2000-3 Arapaho Road  
TU Electric - 1999

Re: Arapaho Rd / Edwin Lewis Drive

Re: Arapaho Rd / Quorum Rd

CONSTRUCTION SEQUENCE
PHASE
<b>ARAPAHO</b>
ADDISON ROAD TO DALLAS
TOWN OF ADDISON

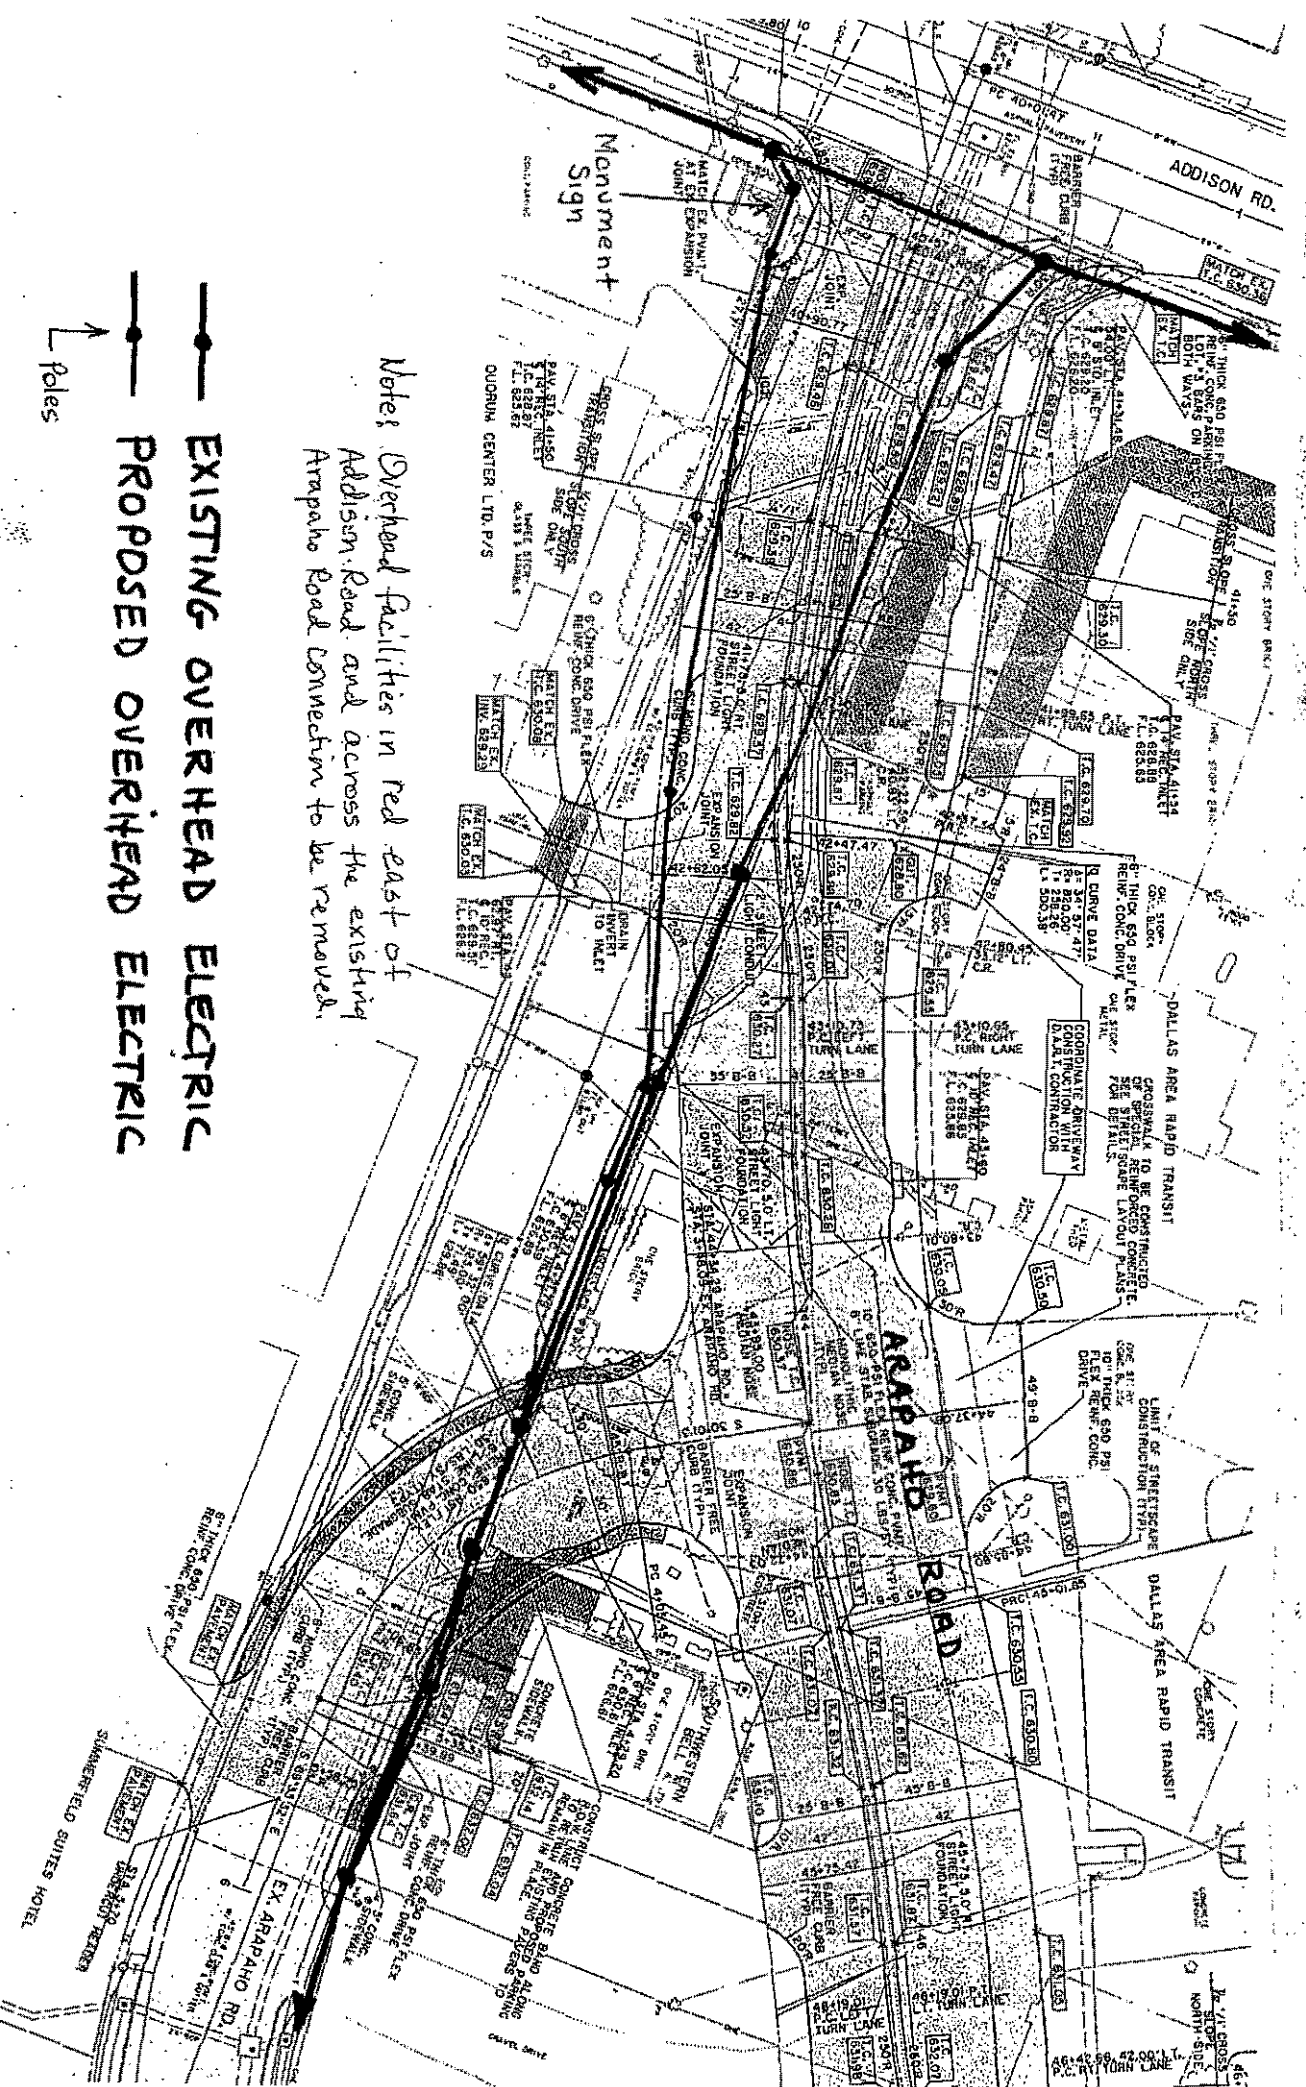
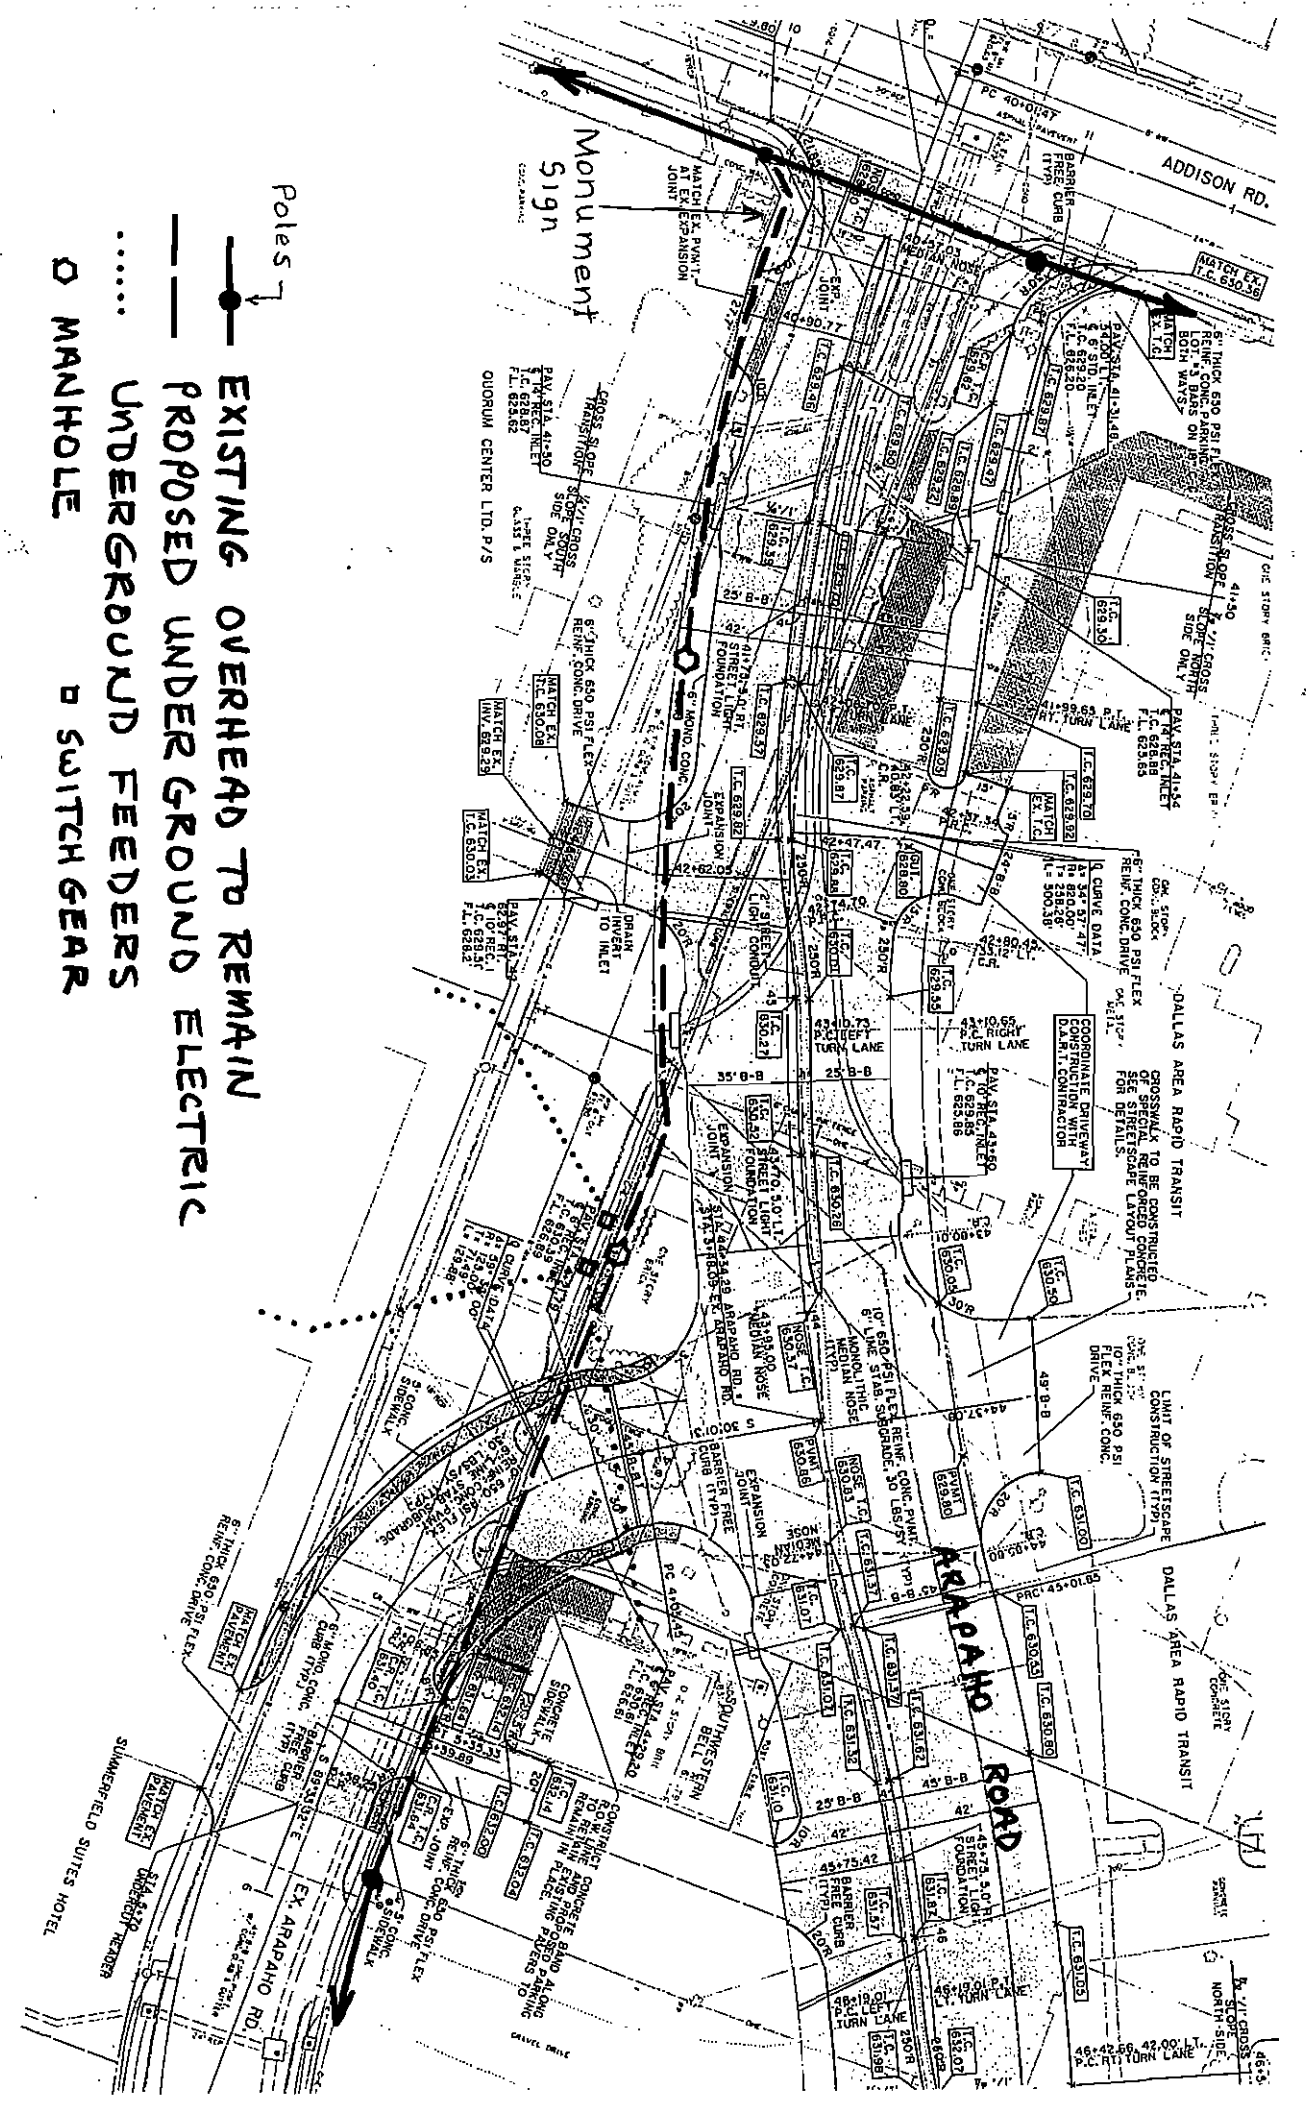
Notes: Overhead facilities in red east of Addison Road and across the existing Arapaho Road connection to be removed.
